Evaluation of Adopted Flow Standards for the Trinity River, Phase 2

For: Trinity and San Jacinto Rivers and Galveston Bay Stakeholder Committee through the Texas Water Development Board

Contract No. 1600011940
Final Report – November 2017

Figure 5. 080486 Grand Prairie - Inundation vs flow rate for pulse flows.

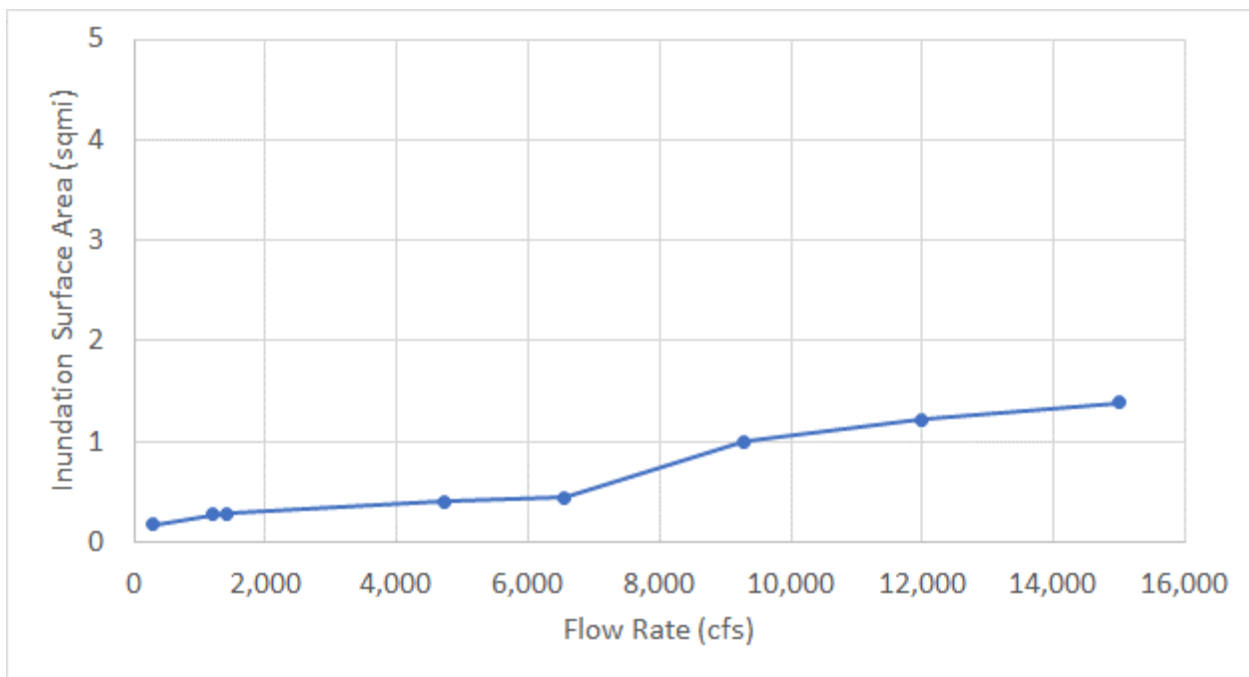
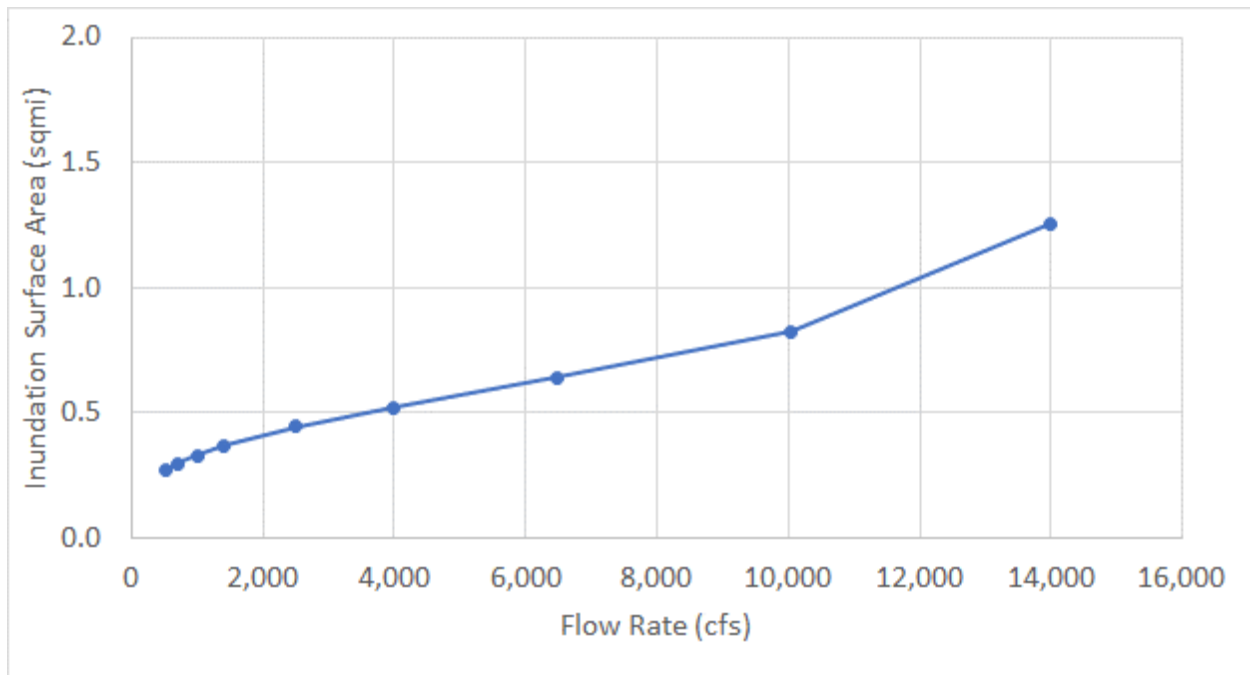
8. Please provide a description of how “inundation surface area”, shown in Figures 5 and 6 on pages 20 and 21, was measured. - **Done**
9. Reference to “segment C3” on page 21, 1st paragraph, 1st sentence is confusing. Please provide a description for this term. – Deleted reference to C3, not needed for this report

Figure 20. 080295 XS1 – Upstream riparian cross-section trees with flow levels. Note: 7,000 cfs, 3,000 cfs, and 2,500 cfs correspond to the SB3 pulses required for this site.

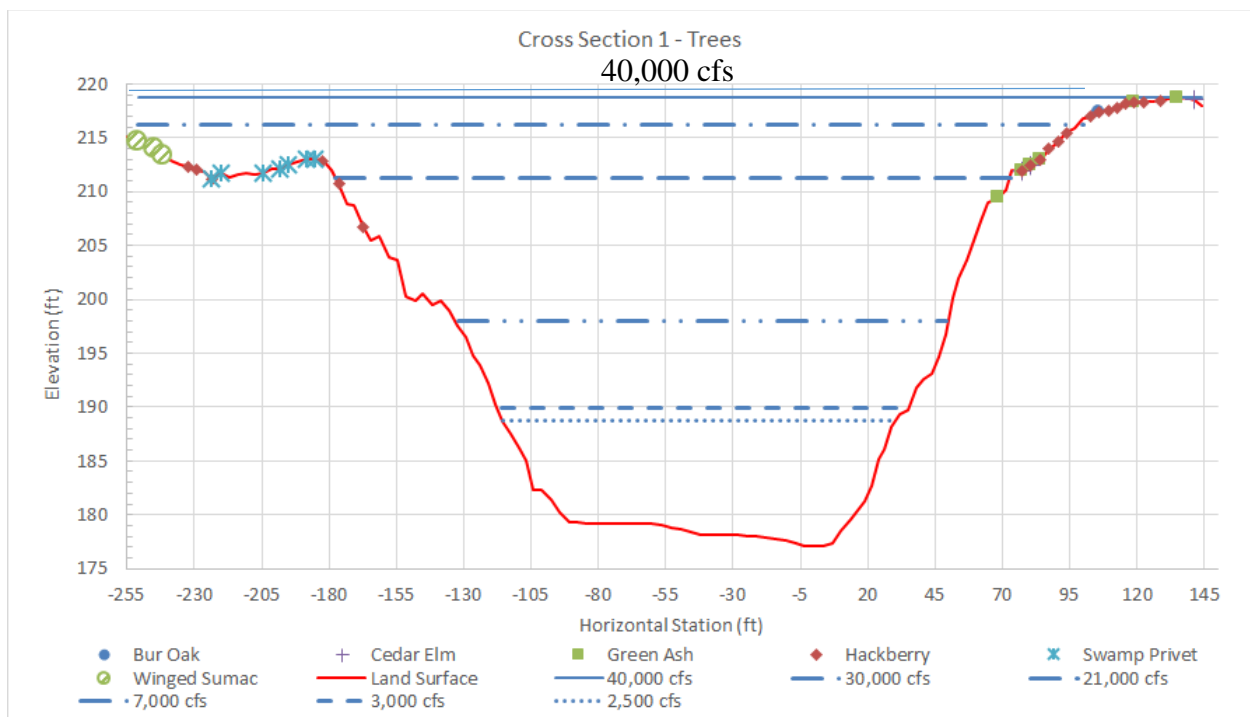
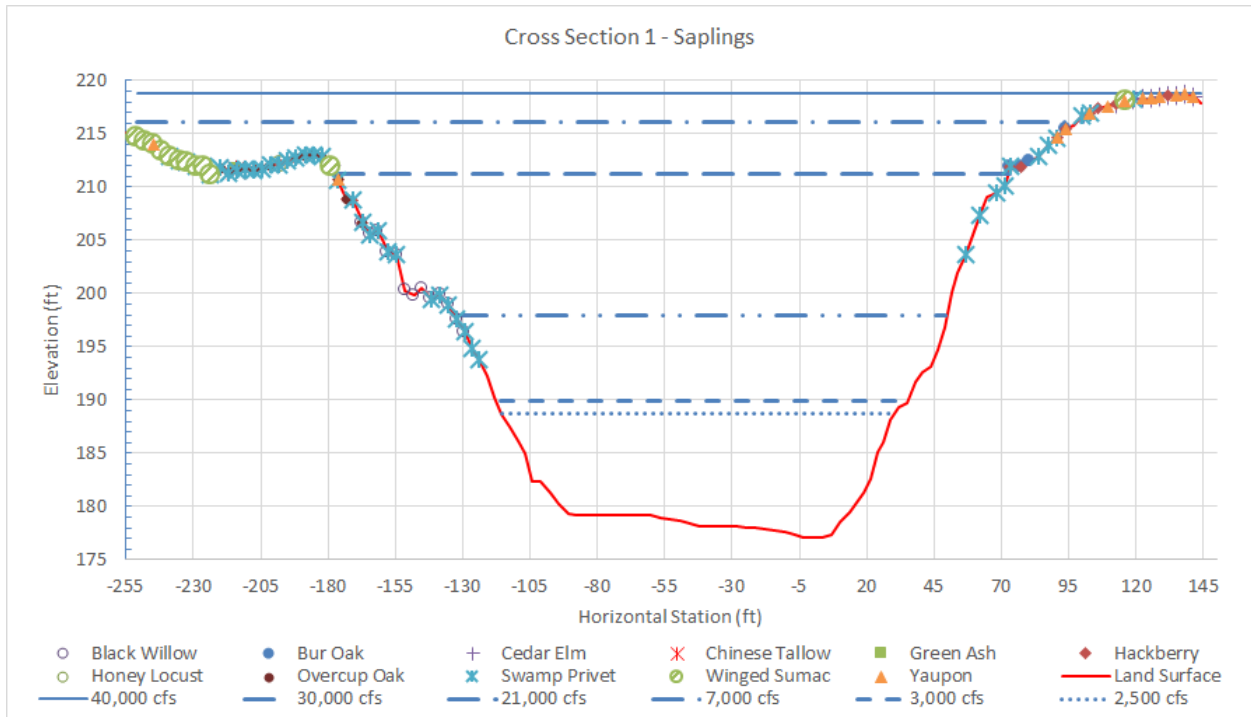
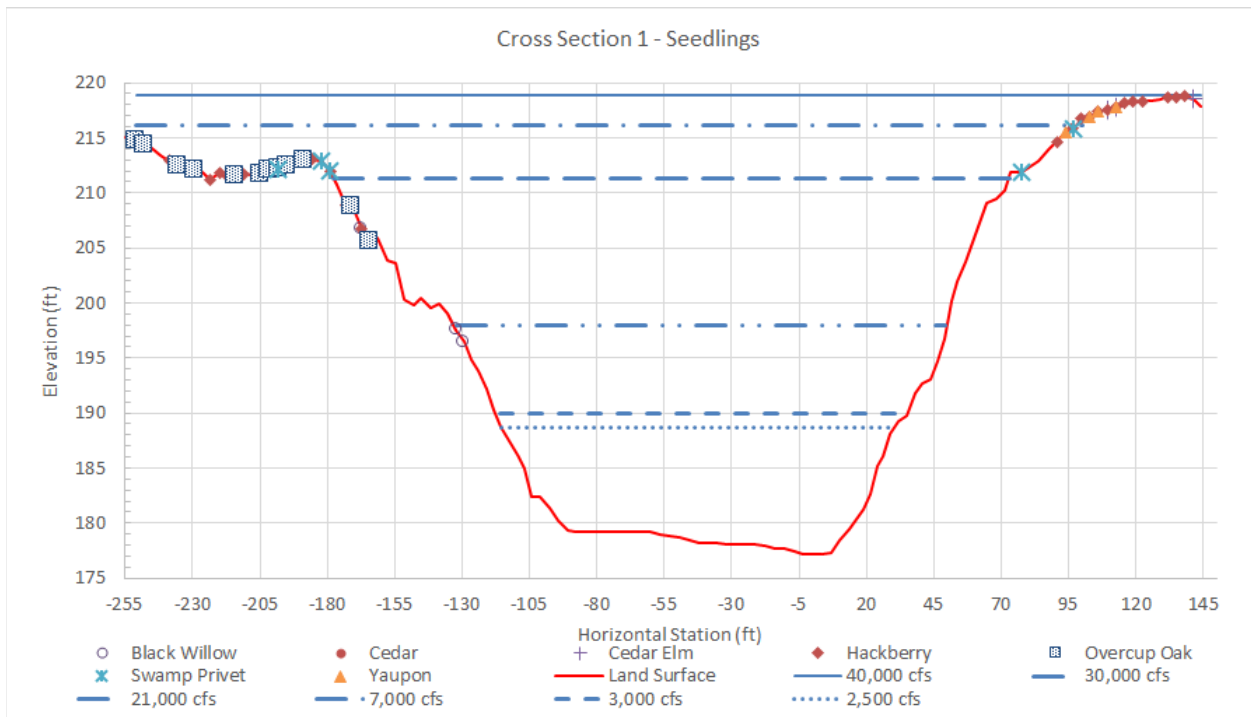
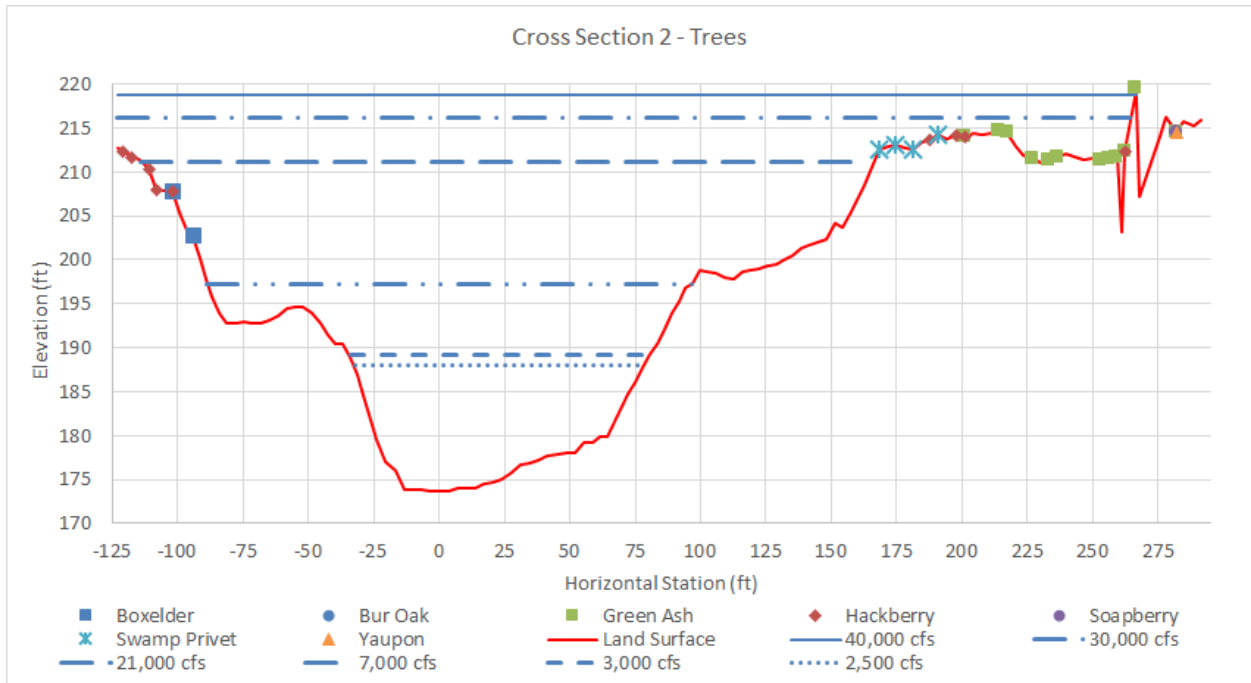
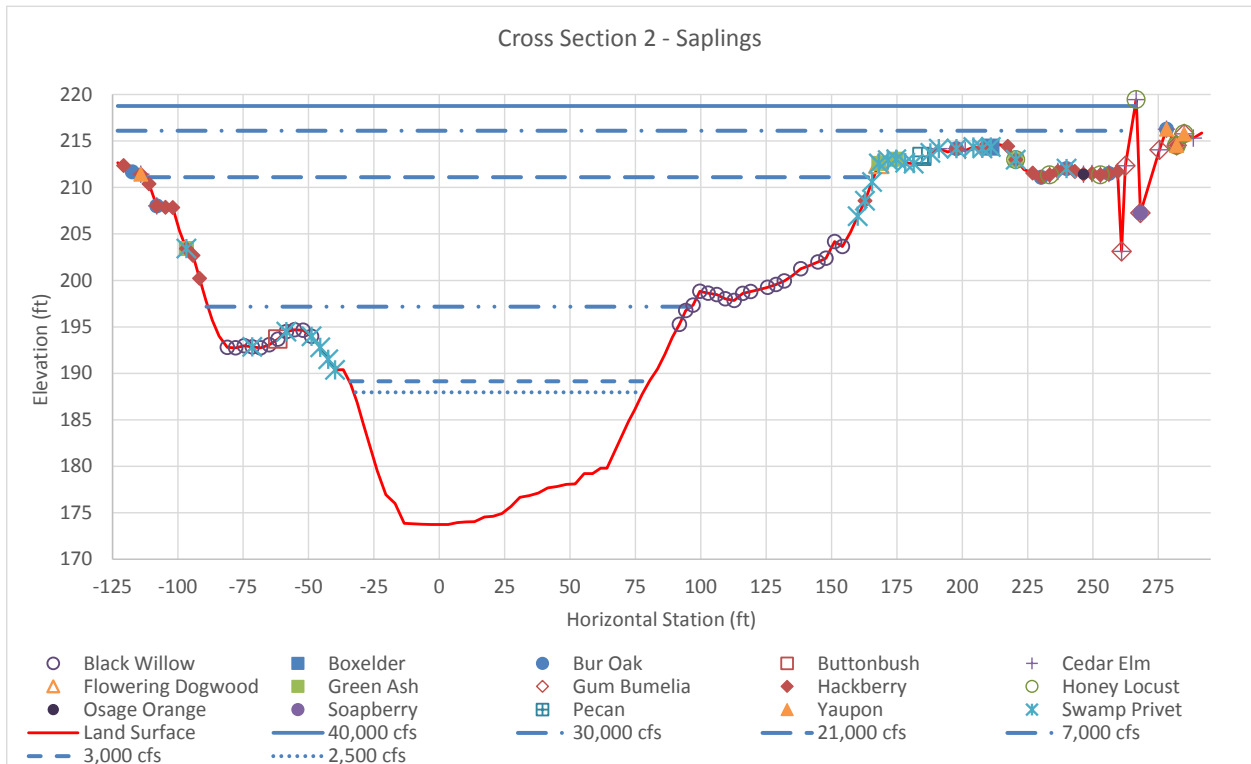
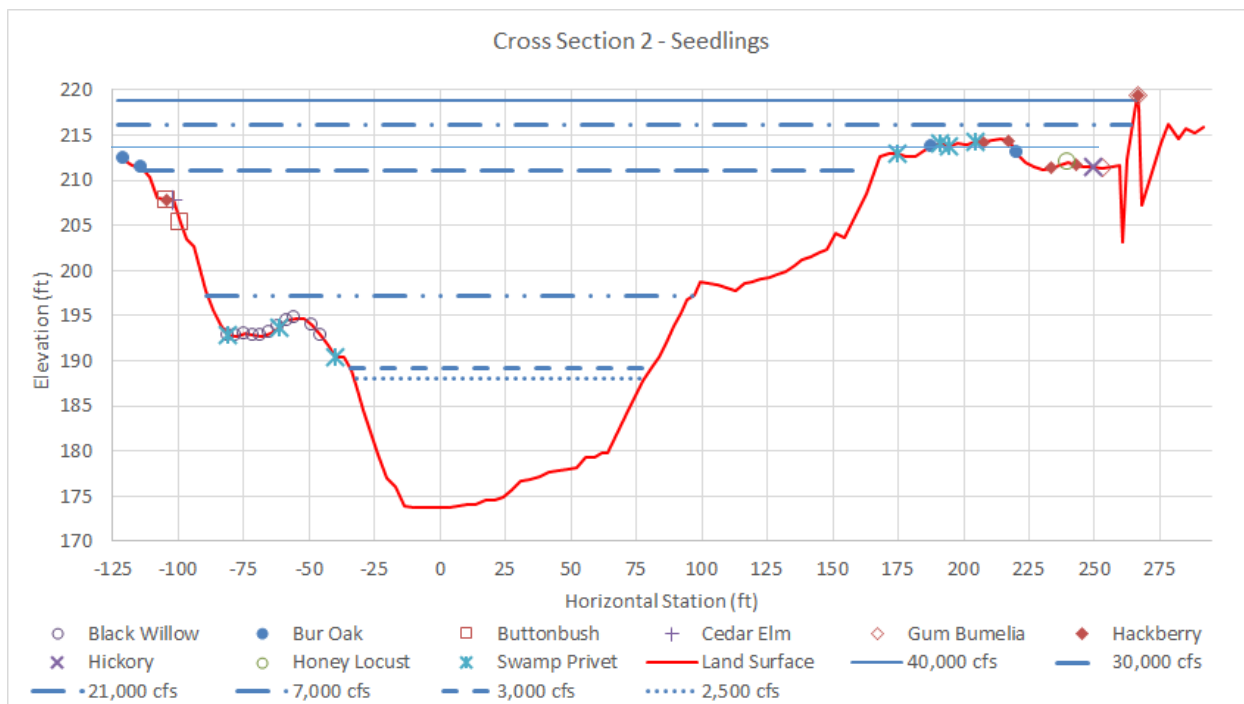
21. Please consider plotting water surface elevations for flows that provide inundation to the riparian forest community in Figures 20 through 25 on pages 36-39 (mentioned in the text as ranging from 21,000 to 30,000 cfs). – **Done** Also, consider explicitly stating in the text or figure legend that water surface elevations for flows of 2,500 cfs, 3,000 cfs, and 7,000 cfs correspond to pulse flows currently in the standards for this location. – **Added note to captions: “Note: XXXX cfs, XXXX cfs, and XXXX cfs**

Figure 29. Segment C3 upstream and downstream of 080295 3 of 4 - Observed inundation and connectivity areas over the RAS 13400cfs inundation map (orange). Note: Numbers represent approximate river mile.

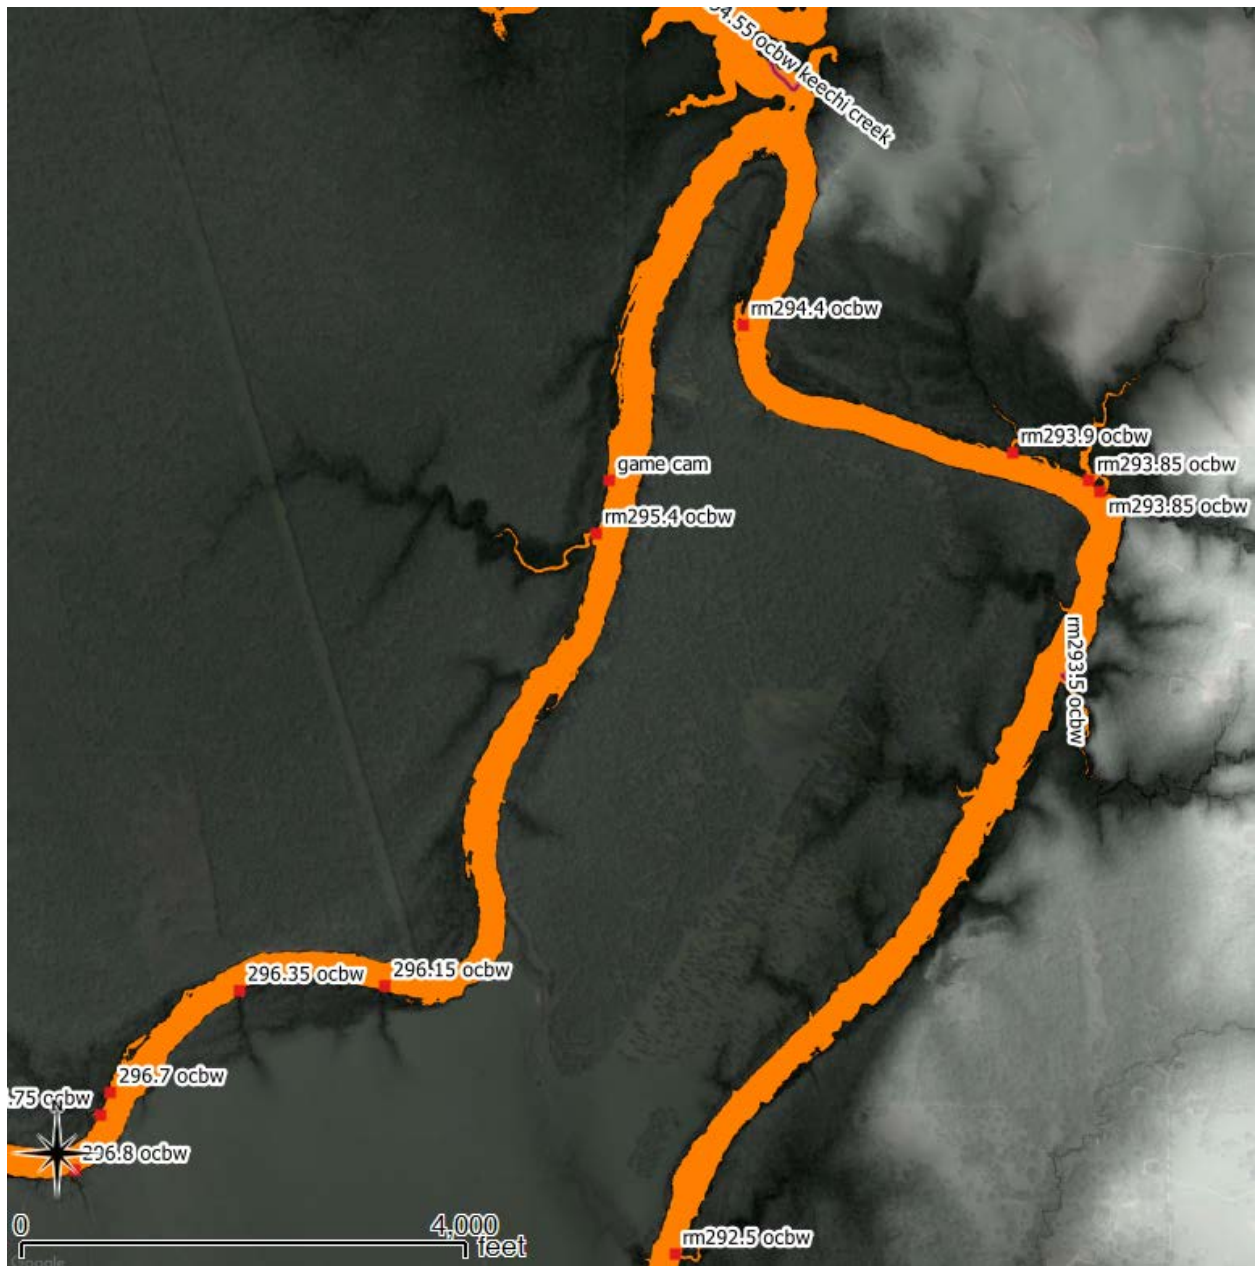
16. On Figures 26-29 on pages 56-59, please provide a description of what the numbers on the figures represent (e.g. water surface elevations, river mileage). – **Added: “Note: Numbers represent approximate river mile.”**
